Accessibility Site Visit Report - HC - ANSI

Project Name	Sample Property
Visit Type	3rd
Date of Inspection	02-12-2020
Inspector	Brian White
Site Visit Accompaniment	Jason Pendly
Street Address	123 Main St
City	Greenville
State	South Carolina
Zip Code	29605
Accessibility Codes for this project (Check if used)	2010 ADA, ANSI A117.1, UFAS
Number of Buildings	1
Total Number of Units	80
Number of HC Accessible Units	5
Number of A/V Units	0
Number 1 Bedroom Units (Std/HC)	80/5
General Project Notes:	NOTE – Element Findings at Time of Inspection: This inspection report indicates individual elements as Yes, No, or N/A. Each

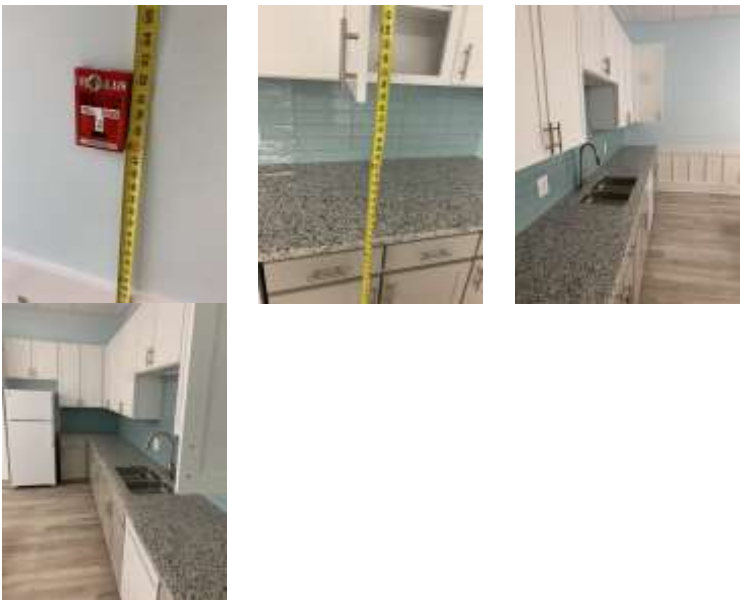
Accessible Route Location	Basement Entrance from HC Parking
Status of accessible route	Finished
Where the accessible route on the site crosses a vehicular roadway, crosswalk lines are provided.	N/A
Accessible route a minimum of 36" (ADA 403.5.1 UFAS 4.3.3)	Yes
Cross-slope is no more than 2% (ADA 403.3 UFAS 4.3.7)	Yes
Forward slope doesn't exceed 5% for a horizontal run over 6 feet and will not require handrails. (ADA 403.3)	Yes
No protruding objects (fire extinguishers, signs, light fixtures, shelves, etc.) project more than 4" between 27" and 80" (ADA 307.3 UFAS 4.4.1)	Yes
18" min clearance with firm surface provided on pull side of the gate (ADA 404.2.4.1)	Yes
Add Photos of Accessible Route

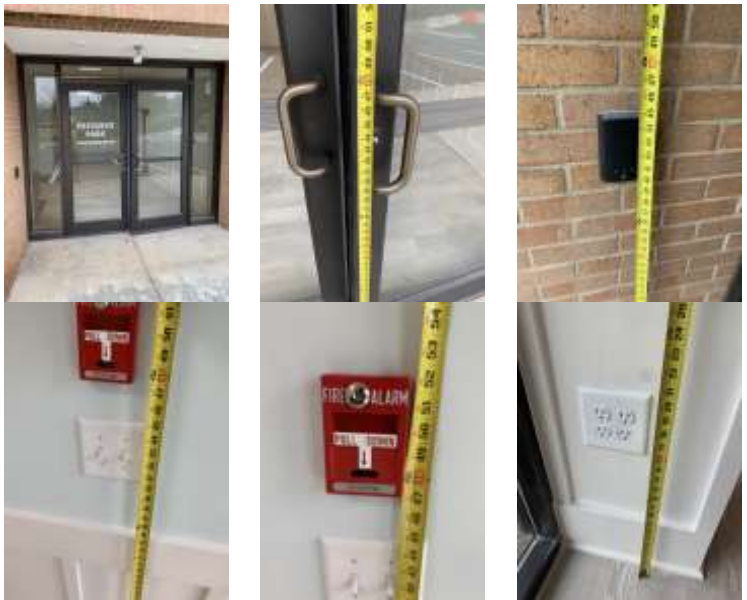
Status of this area	Finished stage
Doorway has a clear opening width 32" min. (ADA 404.2.3)	Yes
Threshold less than 1/2" with bevel or 1/4" no bevel (ADA 404.2.5)	Yes
Interior signs mounted (latch side) have tactile characters (measured from the baseline) between 48" min. - 60" max. (ADA 703.4.1)	Yes
Interior sign characters at least 5/8" but no more than 2" tall (ADA 703.5.5)	Yes
Electric switches/outlets 44" max. AFF over workspace others behind counter 46" max. AFF (ADA 308.2.2 (b))	Yes
Kitchen counters 34" max. AFF (ADA 804.3.2)	Yes
Top lip of kitchen sink 34" max. AFF (ADA 606.3)	Yes
Kitchen sink has 27" knee clearance, 30" clear width, and 9" min. height toe clearance (ADA 306)	Yes
Are drain and water supply pipes insulated or covered by skirt (ADA 606.5)	Yes
Faucet controls Lever Handle style or easy to operate (ADA 309.4)	Yes
Pass through kitchen has 40" min. clear width (ADA 804.2.1)	Yes
At least 50% of shelf space within 48" max - 15" min AFF (ADA 804.5)	No

HC Unit Entrance

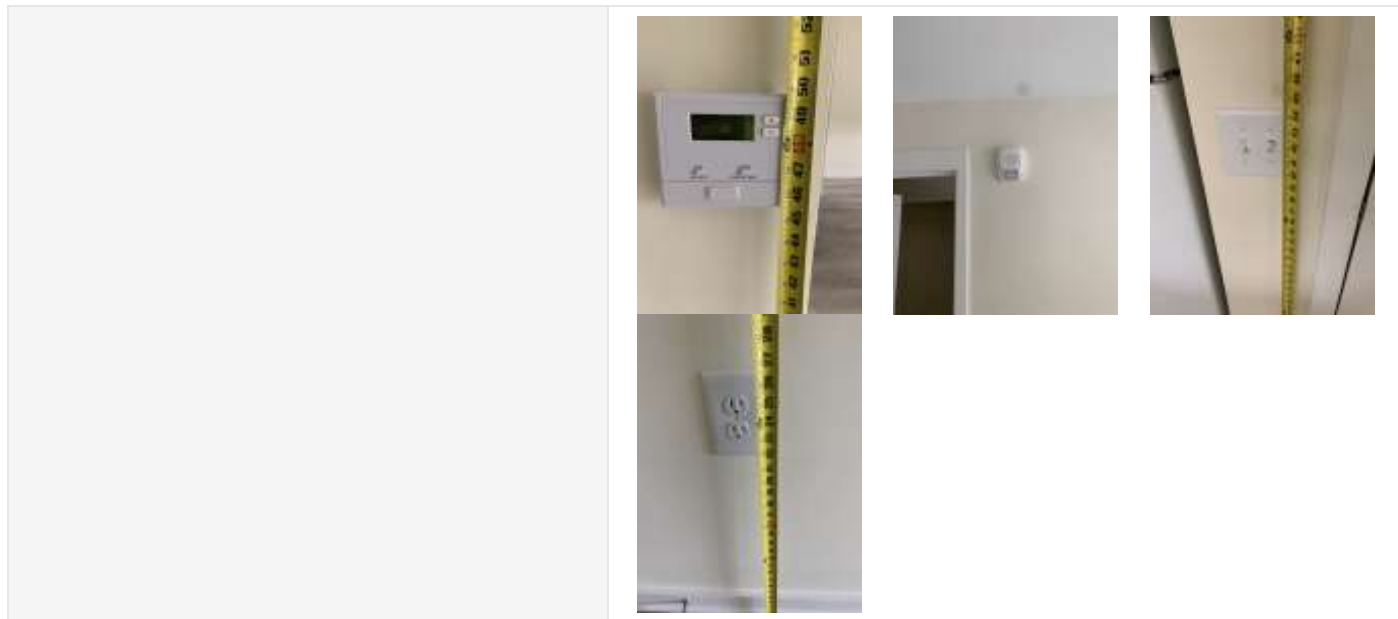
Unit Number	8109
Exterior unit sign mounted have braille between 48" min. - 60" max.(ADA 216.2)	Yes
Number of HC Bedrooms	1

Type of shower/bath	Roll-in Shower
Entrance landing 60" x 60" (Pull side) or 48" x 48" (Push side) with slope 2% or less in all directions (ANSI 404.2)	Yes
Primary Entrance has lower peephole 43" min. - 48" max. AFF (ANSI 404.2.10)	Yes
Primary Entrance - Door hardware lever handle style (ANSI 404.2.6)	Yes
Primary Entrance - clear width 32" min. (ANSI 404.2.2)	Yes
Primary Threshold less than 1/2" with bevel (ANSI 303.3)	Yes
Primary Entrance - 18" min. clearance on pull side of the door (ANSI Table 404.2.3.2)	Yes
Unobstructed thermostat 48" max. AFF (ANSI 308.2)	No
36" min width accessible route through dwelling unit (ANSI 403.5)	Yes
Hallway 48" min width with doors to rooms intended for entry swinging into same area intended for passage (ANSI Fig 404.2.3.2)	Yes
If required per NFPA fire alarm permanently installed with audible/visible alarms	Yes
Photos for HC Unit Misc.

HC Unit Kitchen

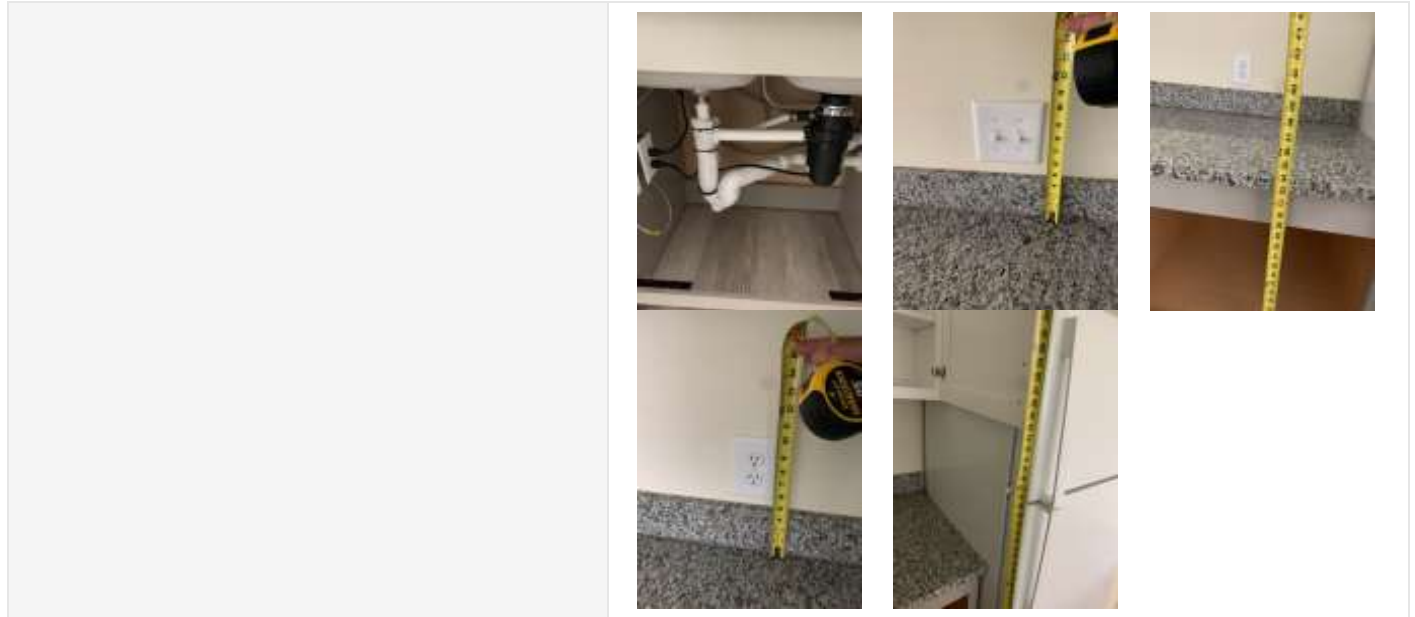
Status of this area	Finished stage
Entrance to kitchen 32" min. (ANSI 404.2.2)	Yes
Electric switches/outlets 46" max. AFF over 24" counter-top obstruction (ANSI 308.3.2)	Yes
Kitchen counter at workspace 34" max. AFF (ANSI 804.3 & 308.3.2)	Yes
Removable cabinet provided at sink with necessary knee clearance for forward approach provided (ANSI 305 & 306))	Yes
Top lip of kitchen sink, 34" max. AFF (ANSI 606.3))	Yes
Are drain and water supply pipes insulated or covered by skirt (ANSI 606.6)	Yes

Faucet controls Lever Handle style or easy to operate (ANSI 309.4)	Yes
U-Shaped kitchen has 60" min. clear width (ANSI 804.2.2)	Yes
Clear floor for parallel approach is provided or forward approach to kitchen sink has 27" knee clearance, 30" clear width, and 9" min. height toe clearance (ANSI 804.5.3)	Yes
Workspace has 27" knee clearance, 30" clear width, and 9" min. height toe clearance (ANSI 306))	Yes
Cabinet hardware easily operated with one hand (ANSI 309.4)	Yes
Range hood fan/light switches installed within accessible reach range 44" max. AFF over workspace others 46" max. AFF (ANSI 309.4))	Yes
Range has controls located in front and oven self-cleaning (required if workspace not located adjacent to oven)	Yes
Refrigerator has 50% of freezer space below 54" max. AFF (ANSI 804.5.6)	Yes
HC Unit Kitchen Photos
